# UNITED STATES PATENT AND TRADEMARK OFFICE

APPLICATION NO.	FILING DATE	FIRST NAMED INVENTOR	ATTORNEY DOCKET NO.	CONFIRMATION NO.
10/811,667	03/29/2004	Derrick Douglas Little	9D-RG-20087 CIP	2435

<b>Office Action Summary</b>	<b>Application No.</b> 10/811,667	<b>Applicant(s)</b> LITTLE ET AL.	
	<b>Examiner</b> Sarah Suereth	<b>Art Unit</b> 3749

## **DETAILED ACTION**

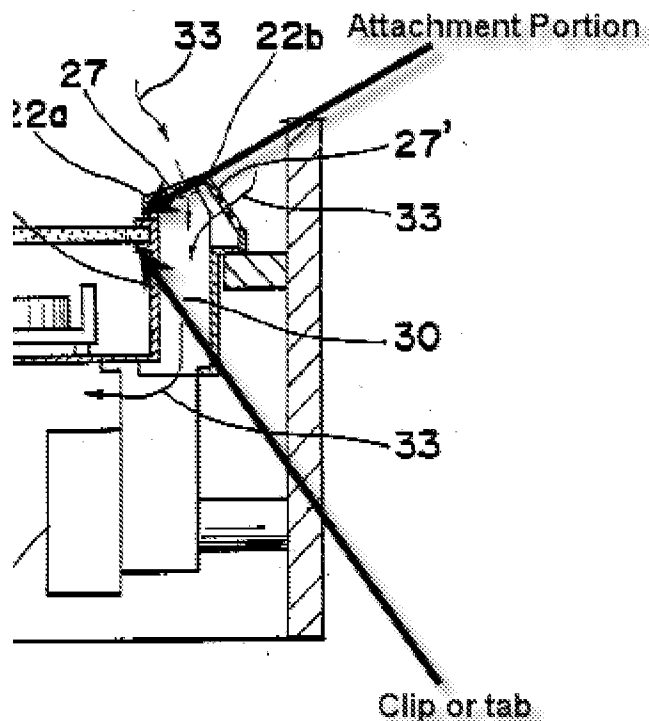
Arai discloses a stove vent trim element (22) shown mounted to the rear surface of a cooktop (20). The vent trim includes an upper horizontal flange regarded as the claimed attachment portion, and a lower horizontal flange regarded as the claimed clips or tabular portion along the bottom of the cooktop surface. A portion of Arai Figure 2 has been relabeled below for clarity.

It would have been obvious to one of ordinary skill in the art at the time the invention was made to modify the Levi apparatus to include the vent trim structure of Arai in order to further elevate the vent cover from the cooktop structure. Levi shows the vent cover essentially parallel, while Arai teaches a sloped surface. The sloped surface of Arai obviously aids in preventing liquids from accidentally entering the burner ventilation structure.
